**ADDENDUM #3
TO SPEC. 06-262**

**FIRE STATION EXHAUST REMOVAL SYSTEM
UPGRADE**

Addendum #3 to Spec. 06-262 for **Fire Station Exhaust Removal System Upgrade**, bids to be opened on Wednesday, September 27, 2006 at 12:00 noon.

SD-
E001

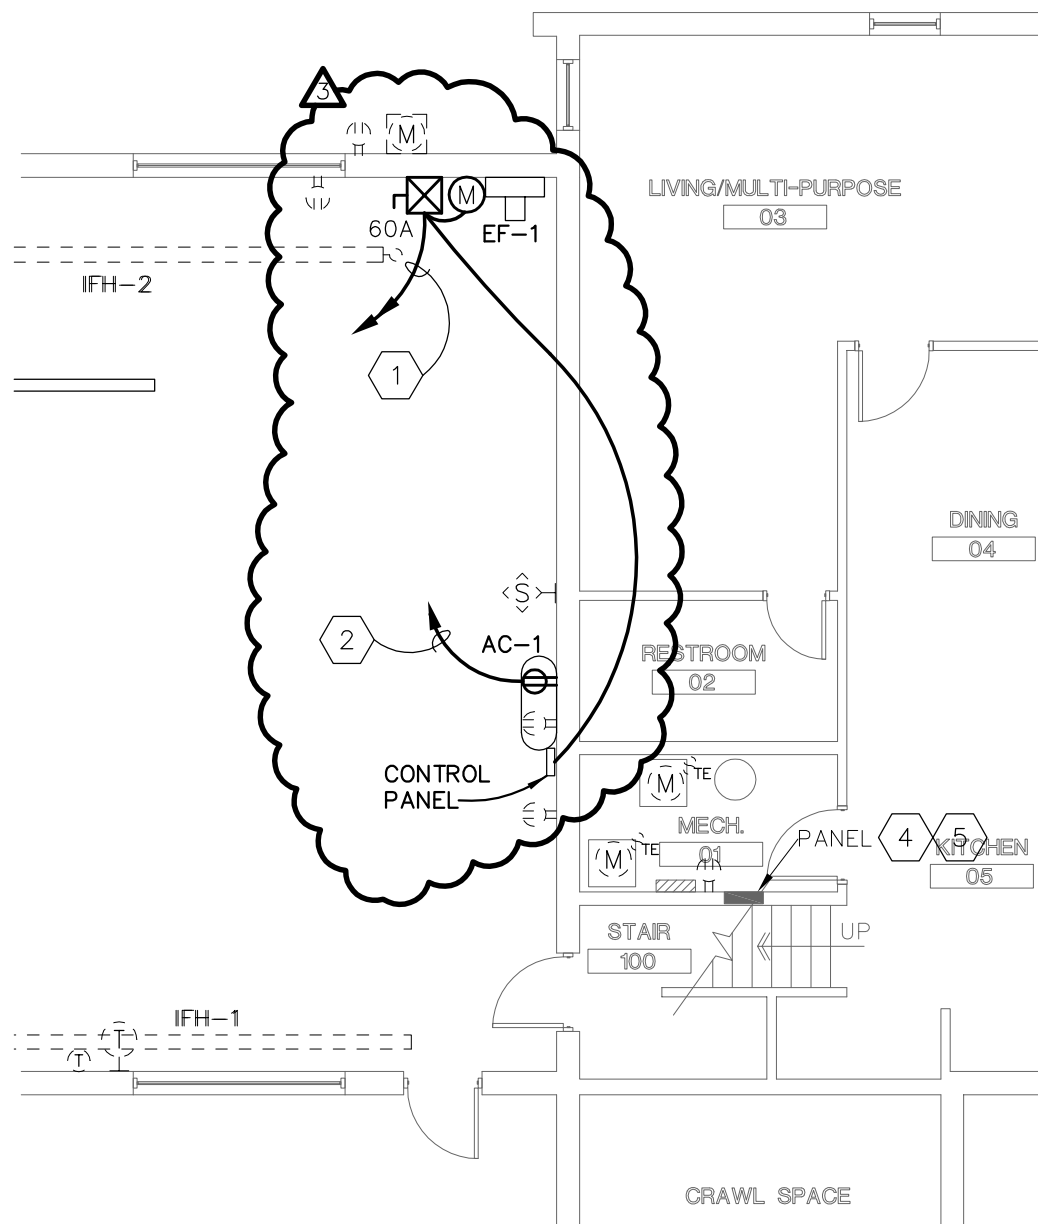
1. Electrical Contractor to conceal conduit whenever possible. When wiremold is required, utilize wiremold 700 series painted to match ceiling or wall in hallways and living areas. Exposed conduit is acceptable in the Apparatus bays.
2. All low voltage control wiring between apparatus bay exhaust fan and control panel to be in $\frac{3}{4}$ " conduit.
3. Exhaust fan EF-1's motor starter should be 30amp in lieu of 60amp in Fire Stations #3, 5, 6, 9, 10 & 14.
4. See attached wiring diagram for the exhaust fan and the control panel for additional electrical information. See attached sketch sheet SD-E002.
5. See attached typical electrical floor plan for wiring and circuit changes. The dedicated circuit for the control panel was not required (see attached wiring diagram). See attached sketch sheet SD-E001.

1 ROUTE 2#12 & 1#12GRND IN 3/4" C FOR NEW APPARATUS BAY EXHAUST FAN EF-1 TO NEW 20AMP, 2-POLE BREAKER IN EXISTING PANEL LOCATED IN EXISTING MECHANICAL/ELECTRICAL ROOM, NEW BREAKER WILL BE INSTALLED IN SLOTS #2,4, MATCH EXISTING AIC RATING. MOUNT MOTOR STARTER ON WALL NEAR EXHAUST FAN. SEE CONTROL PANEL AND EXHAUST FAN WIRING DIAGRAM.

2 ROUTE 2#12 & 1#12GRND IN 3/4" C TO SPARE 20AMP, 1-POLE BREAKER SLOT #25 IN EXISTING 200A PANEL LOCATED IN FIRST FLOOR MECHANICAL/ELECTRICAL ROOM FOR NEW WALL MOUNTED RECEPTACLE SERVING NEW 2 HP AIR COMPRESSOR, COORDINATE MOUNTING HEIGHT OF RECEPTACLE WITH MECHANICAL AND EXISTING CONDITIONS.

4 EXISTING 200AMP, 120/240V, 1 ϕ PANEL. REMOVE EXISTING 25AMP, 2-POLE BREAKER SERVING DEMO'D APPARATUS BAY EXHAUST FAN. SEE NOTE #1 FOR NEW BREAKER INSTALLATION.

5 ELECTRICAL CONTRACTOR TO METER EXISTING PANEL FOR EXISTING LOAD TO VERIFY CAPACITY FOR ADDED LOAD.
